DESIGN REVIEW BOARD – SPECIAL HEARING

Design Review Board Case # 2021-0001
Block 23 – 2121 and 2111 Eisenhower Avenue

Application	General Data	
Project Name: Block 23 Location: Southern Portion of Block 23 – Eisenhower East/CDD #2 Applicant: Mid-Atlantic Realty Partners c/o Walsh, Colucci, Lubeley and Walsh, P.C.	DRB Date:	September 16 th , 2021
	Site Area:	1.89-Acres
	Existing Zone:	CDD #2
	Proposed Zone:	CDD #2
	Existing Use:	Office (x2)
	Proposed Use:	Multi-Family Residential
	Gross Floor Area:	488,880 square feet
Purpose of Application: Architectural review for the redevelopment of the southern portion of Block 23.

Figure Above: Applicant's initial massing proposal, showing parallel tall sections aligned N-S, with City staff markup.

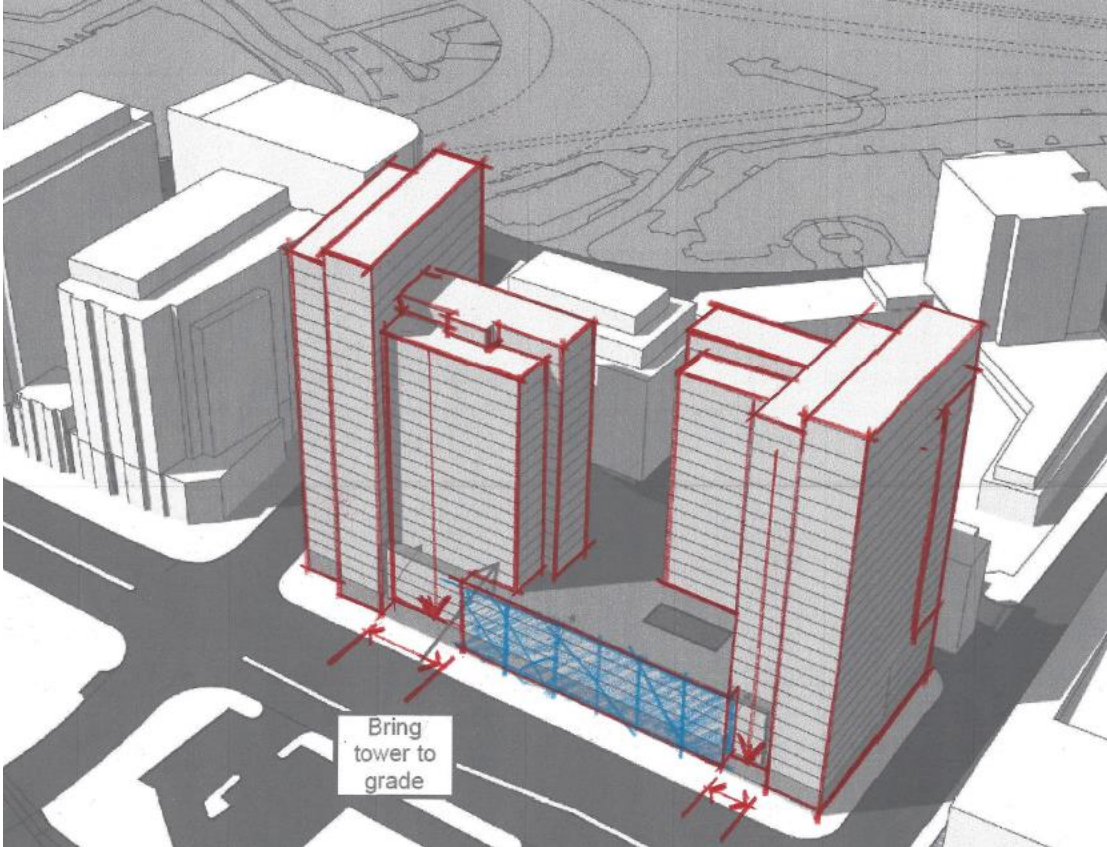
The first concept discussed with Staff incorporated two parallel towers, each with its primary mass oriented north-south and perpendicular to Eisenhower Avenue, with a secondary wing at ninety degrees, parallel to Eisenhower. Staff felt that this resulted in a “twin towers” or “bookends” effect, did not reflect an appropriate level of distinction between the two phases, and was also too similar to the parallelism already present in the Paradigm development to the immediate west of the project site and as recently approved for the first two phases of Block 32.

Staff encouraged the Applicant's design team to explore placing the buildings in a rotated relationship, to create a richer combination of forms – specifically, to let the dominant bar of one remain oriented north-south, while flipping the dominant bar of the other tower to an east-west alignment. Staff further encouraged applicant to develop strongly differentiated skin treatments for each tower, to carry tower architecture all the way to the ground wherever possible, and to use the portion of the screened garage that fronts on Eisenhower Avenue to create an element that reads as strongly different from the two towers (for example, horizontal in emphasis, and possibly much more glassy in terms of cladding) with the goal of further emphasizing the dramatic height of the two new residential towers.

A.

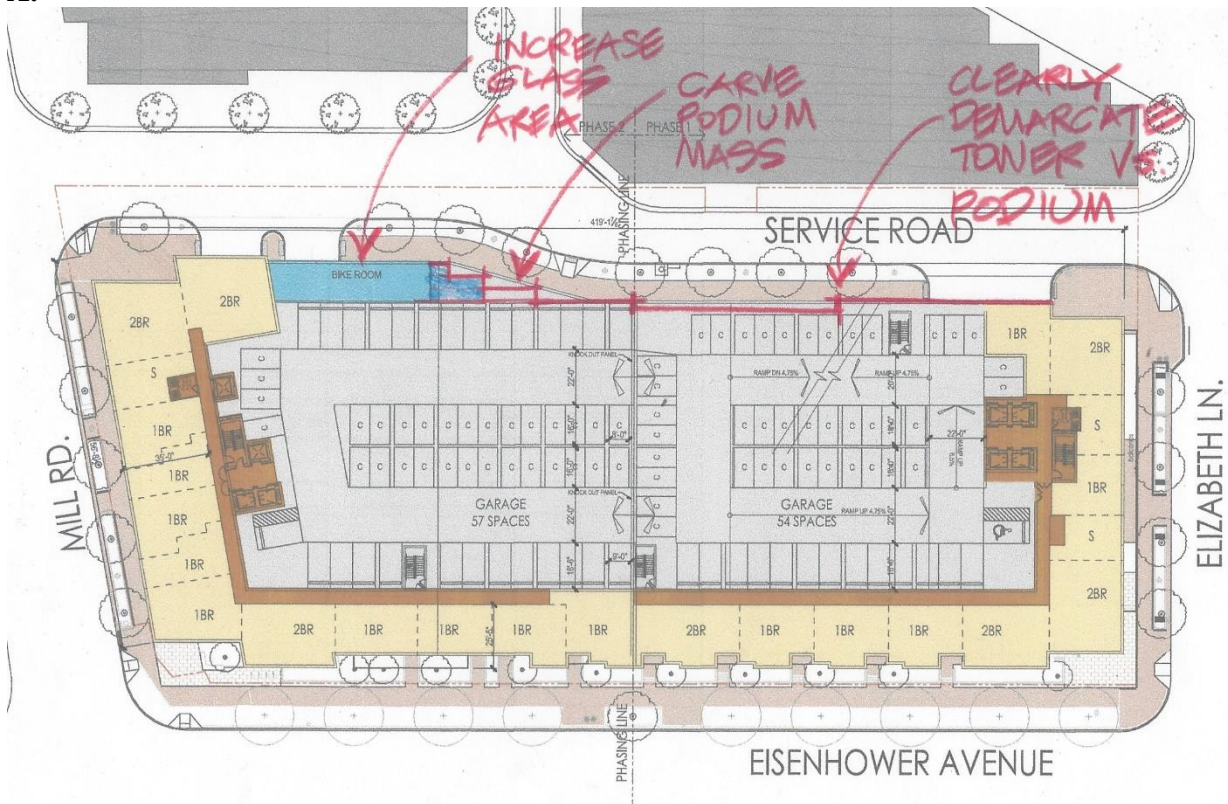
Clarification on pedestrian access to the related ground level areas along the C Street is also necessary. Refer to diagram in **Attachment A**.
